SERVICE BULLETIN

* Supersedes Service Bulletin SB900-089, dated 18 October 2002. This revision adds the requirement to remove the hub and inspect the thread area.

MAIN ROTOR SUPPORT STATIC MAST, ONE TIME INSPECTION

MD-900 helicopters, serial number 900-00008 thru 900-00110.

Figure 1. Main Rotor Support Static Mast

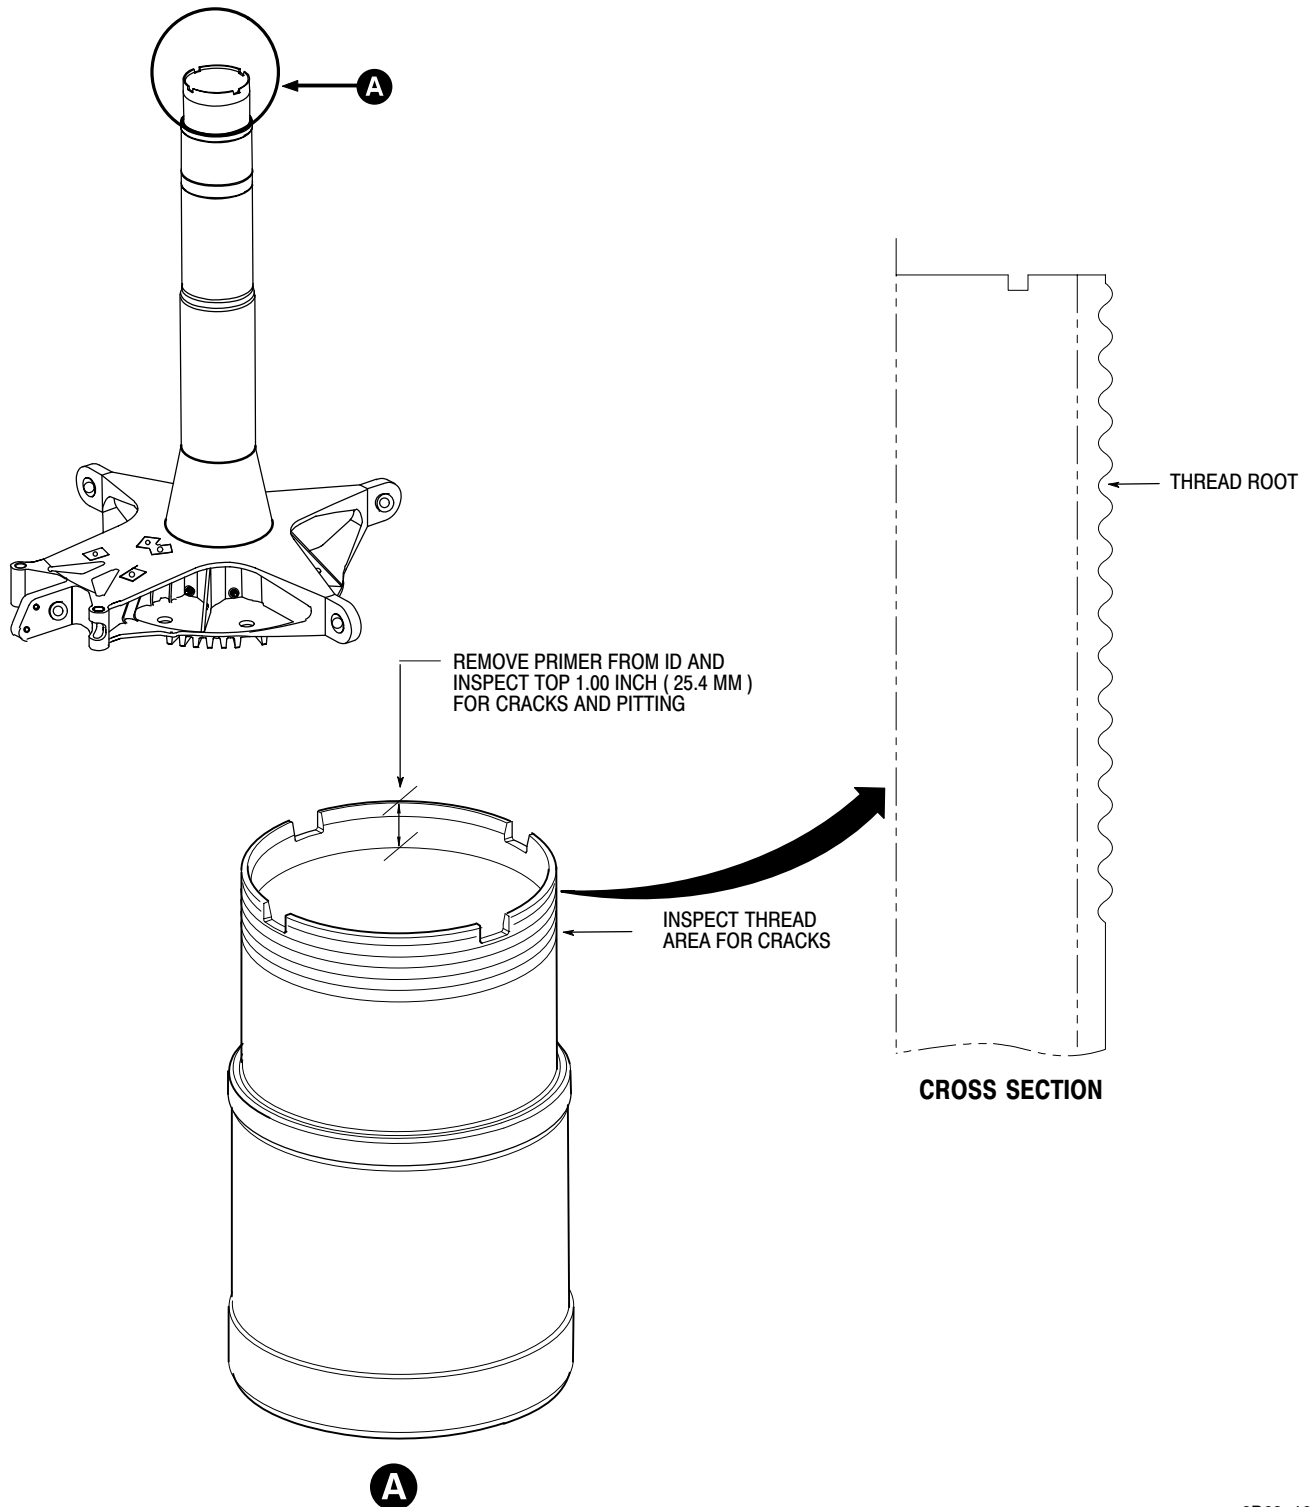
Ref. Figure 1.

- (1). Remove main rotor drive shaft (Ref CSP-900RMM-2, Section 63-10-00, Main Rotor Drive Shaft Removal).
- (2). Using torque wrench (dial indicator preferred), check existing torque in tightening direction of each of the 12 bolts in main rotor retention nut and record on Compliance Recording Form (attached). Torque should be **80-90 in-lbs. (9.0-10.1 Nm)**. (Ref CSP-900RMM-2, Section 62-20-00, Main Rotor Hub Assembly Installation.)

- (3). Inspect top inside diameter (ID) of static mast for cracks and pitting.

- (a). Remove 1 inch (25.4 mm) of primer from top inside diameter of main rotor support static mast (Ref CSP-SPM, Section 20-40-00, Paint Removal Chemical). During paint removal, wipe clean, do not scrub area and do not flush.

- (b). Inspect top 1 inch (25.4 mm) of inside of mast (entire circumference) for evidence of cracks or pitting using bright light and 10x magnification. If there is a crack, the main rotor support static mast must be removed from service. If there is evidence of pitting or other anomaly, contact MDHI Field Service Department for repair disposition before further flight.

- (4). Remove main rotor hub assembly. (Ref CSP-900RMM-2, Section 62-20-00, Main Rotor Hub Assembly Removal.)
- (5). Clean threads thoroughly with solvent. Inspect static mast threads for cracks using bright light and 20x magnification. Pay particular attention to thread root area. If defects or suspect cracks in thread area are found, perform magnetic particle inspection (wet fluorescent) per ASTM E 1444-01 using electromagnetic yoke or coil. If there is a crack, the main rotor support static mast must be removed from service.

- (6). If there is no evidence of cracks or pitting in mast, reapply primer to mast ID and reassemble main rotor drive shaft and hub assemblies (Ref CSP-900RMM-2) and return to service. Perform Main Rotor Drive Plate Nut Torque Verification (Ref CSP-900RMM-2, Section 05-20-10, Special Inspection - After Component Installation.)
